ADDENDUM NO.: 8
 DATE OF CMR ADDENDUM: 1/15/13

Project Name:	JM Wright Tech High School
Project Location:	Stamford CT
Project Description:	Additions & Renovations
Project Construction Budget:	50,000,000.00
CT DCS Project Number:	BI-RT-842-CMR

**JM Wright Technical High School
Stamford, CT
State Project # BI-RT-842-CMR**

**ADDENDUM #8
January 15, 2013**

SKL-01

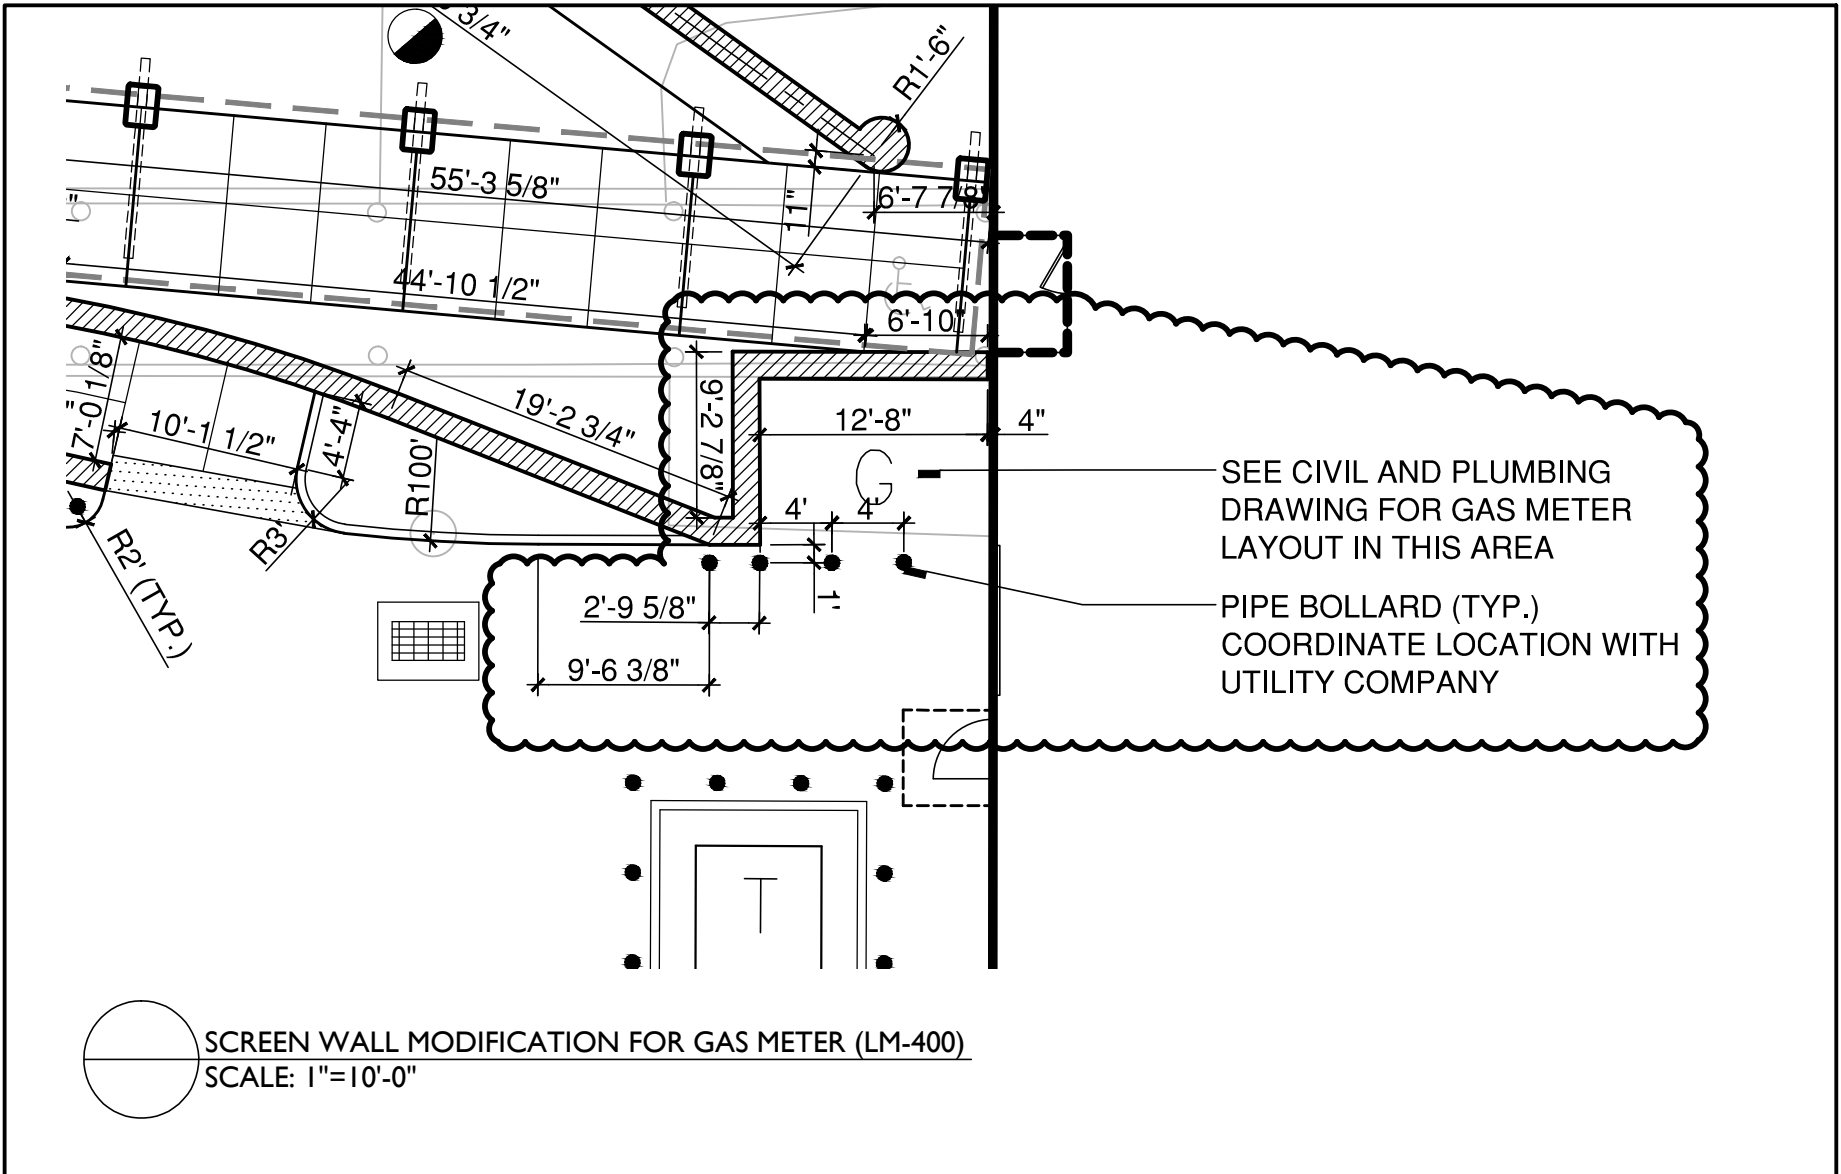
A meeting was held on Site Wednesday 01/09/13 with Yankee Gas and Yankee Gas found that the proposed gas meter location was not acceptable.

KBE and NCA reviewd the location and determined a screen wall could be modified to accommodate the metering by creating a 13 foot clear wall from East to West for the proposed screen wall location.

Please provide revised drawing of screen wall and bollards to protect metering.

Revision made. Sketch attached (SKL-01)
